Due to different opinion between us (Site Office of Kuwait Oil Tanker Company) as Owner and Builder (shipyard DSME –Okpo, Korea) we are kindly asking for clarification of the CSR regarding edge reinforcement and application of full penetration welding.

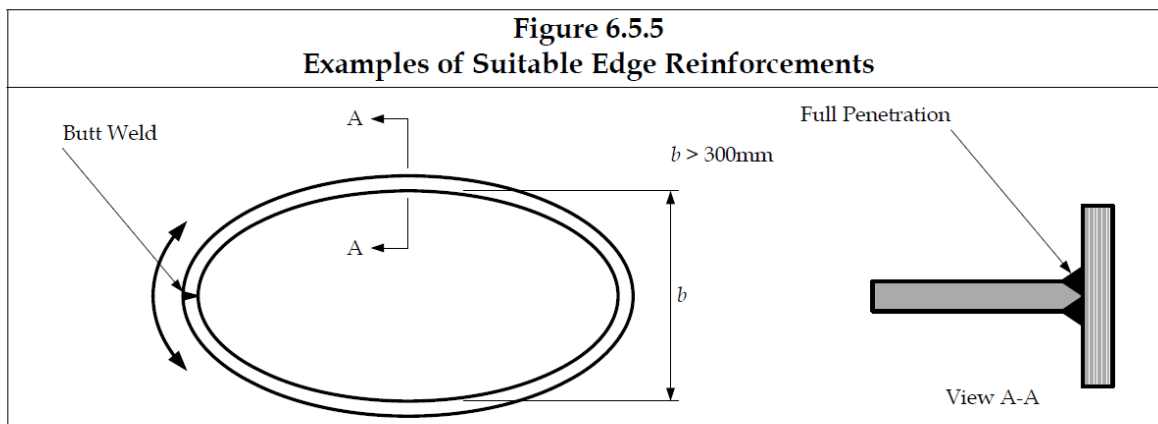
In our opinion sleeve should be considered as edge reinforcement. Figure 6.5.5. (copy down here) from CSR for Double Hull Oil Tankers gives us enough confidence for such opinion.

Do the welds, between sleeves (p/v stand pipe penetration) and strength deck within 0.6L, when transverse dimension of the opening exceeds 300 mm, have to be performed as full penetration welds?
